ProtectLink Dual-Band 700/800 DAS Applies to all ProtectLink BDA's

Software Release Notes

Document Number: CS40- 734834--BDA
Revision: 7.00
Date: June 6th 2023

OFF - NORMAL SUMMARY
LOSS AC POWER

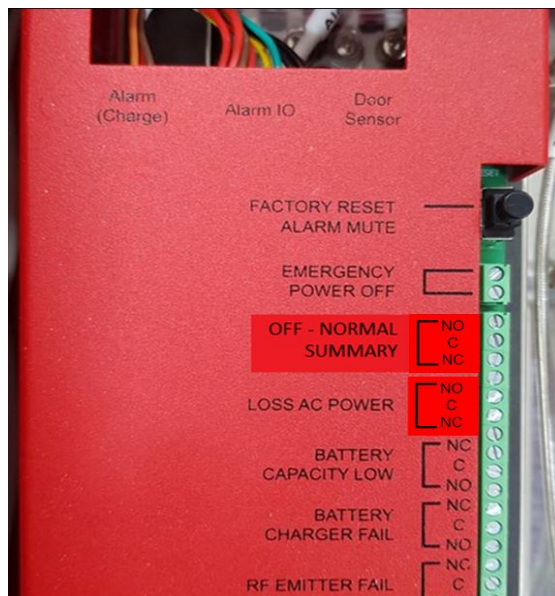
1. Sign into the GUI and mask all alarms on all devices from the Alarm GUI screens.
2. If the current version is pre 2.00.21, the following output relays must be re-wired according to the diagram below:

**OFF - NORMAL SUMMARY
LOSS AC POWER**

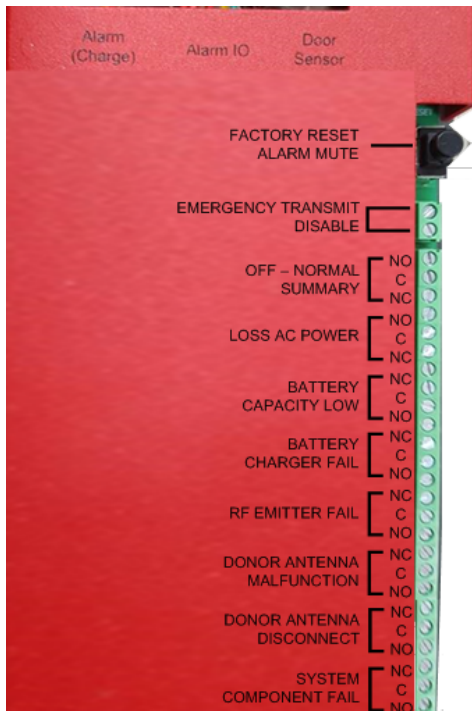
- Background: Defaulted the AC Power Fail and OFF-Normal Summary output relays to 1 which is the charged state. On alarm those relays are now set to 0 or the uncharged state. This allows the relays to indicate failure on complete loss of power by switching the NO and NC contacts.
- **MOP for Alarm Relay migration**
 1. Note the current version
 2. Sign into GUI and mask all alarms on all devices from the Alarm GUI screens
 3. If current version is pre 2.00.21 , the following output relays MUST be RE-WIRED according to the diagram below:
